**AMENDMENT OF SOLICITATION/MODIFICATION OF CONTRACT**

2. AMENDMENT/MODIFICATION NO. A003	3. EFFECTIVE DATE 09/15/2008	4. REQUISITION/PURCHASE REQ. NO.	5. PROJECT NO. (If applicable) HI A-AD 6 (5)
6. ISSUED BY Federal Highway Administration Central Federal Lands Highway Division Attention: Brenda McGehee 12300 W. Dakota Avenue, Suite 360 Lakewood, CO 80228	CODE	7. ADMINISTERED BY (If other than Item 6)	CODE

## STATE ROUTE 200 - SADDLE ROAD PTA-1 SECTION PHASE 5

**PTA QUARRY  
CROSS SECTIONS**

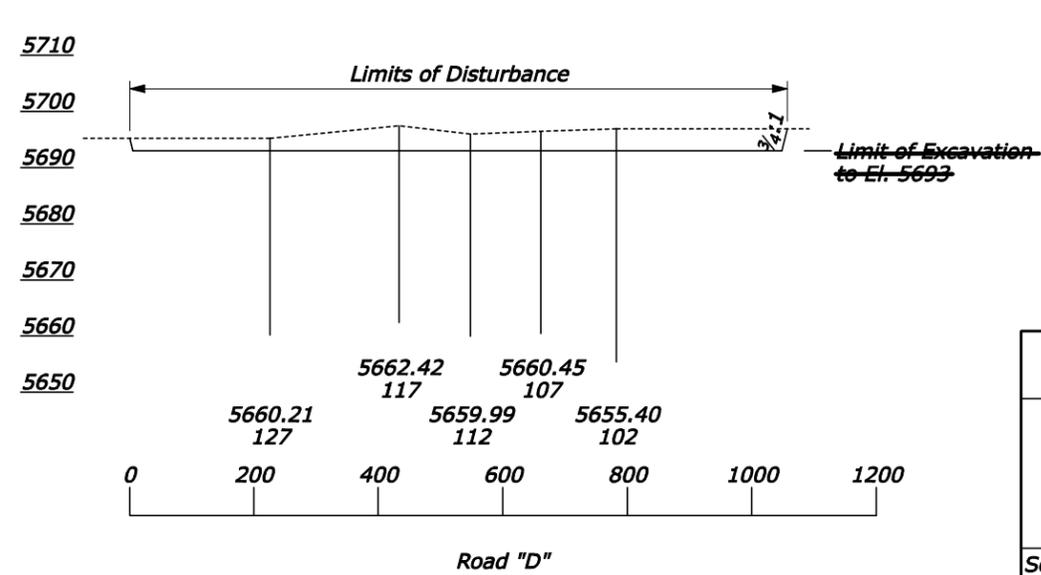
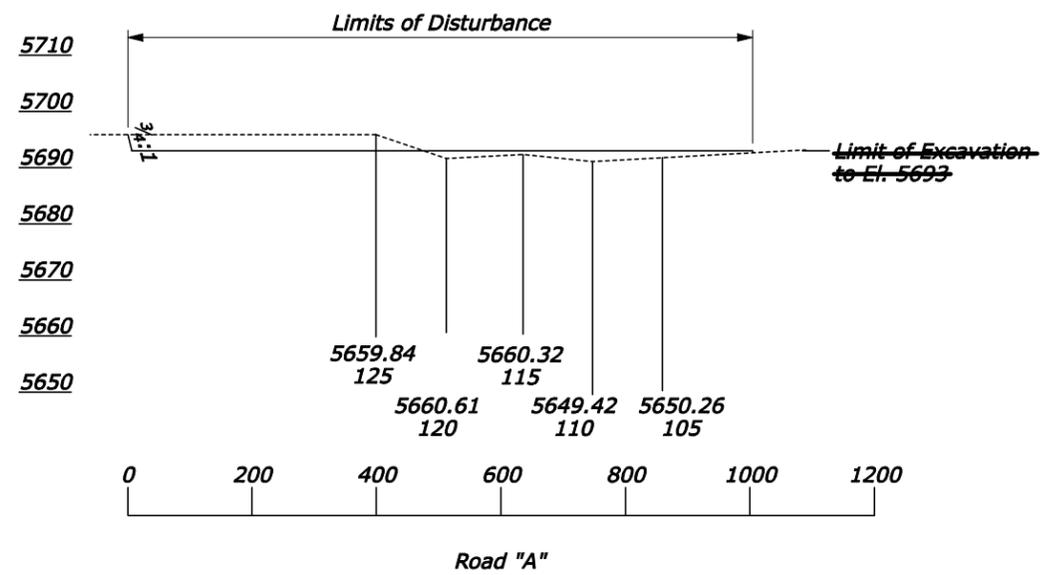
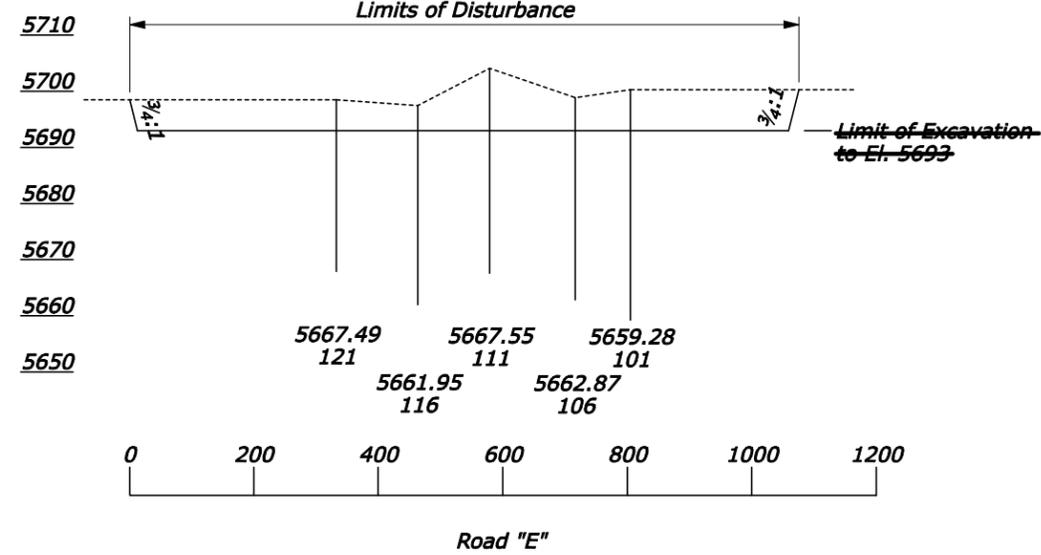
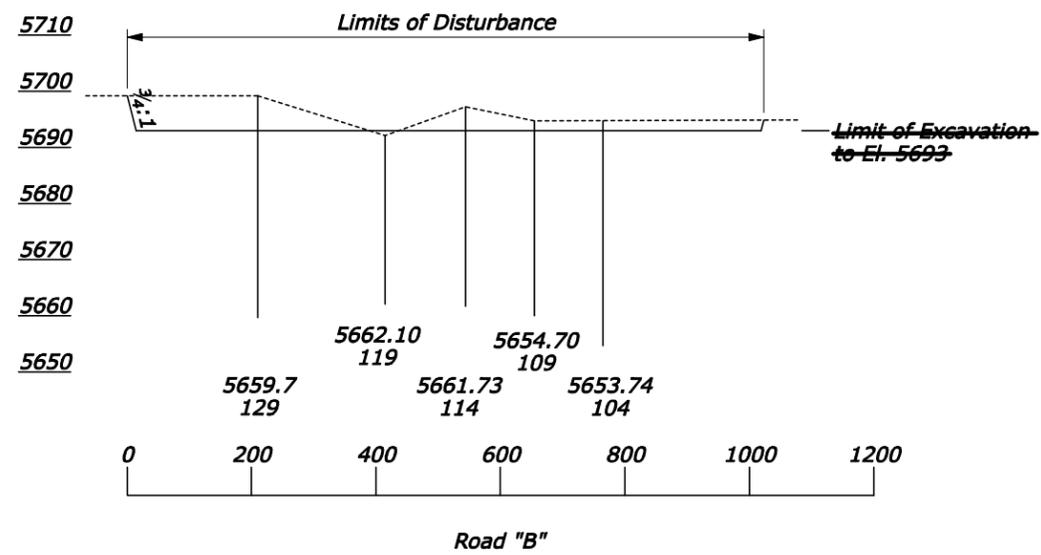
Remove Sheet H-3 and replace with new Sheet H-3 bearing revision date 9/15/08.

Variation should be expected. *All material mined within the mandatory source limits meeting the aggregate quality requirements must be utilized in the production of aggregates. ~~Excavate to, and maintain a base pit elevation no lower than 5693 when mining the quarry.~~ Limit excavation to natural ground line adjacent to the bottom of the lava flow on the Northern boundary. Maximize use of durable “blue” basalt.*

1. **Limit excavation to natural ground level adjacent to bottom of lava flow on northern boundary.**
2. **Backfill any excavations or holes created by quarry operations below the natural ground level to the same elevation with waste or overburden materials.**
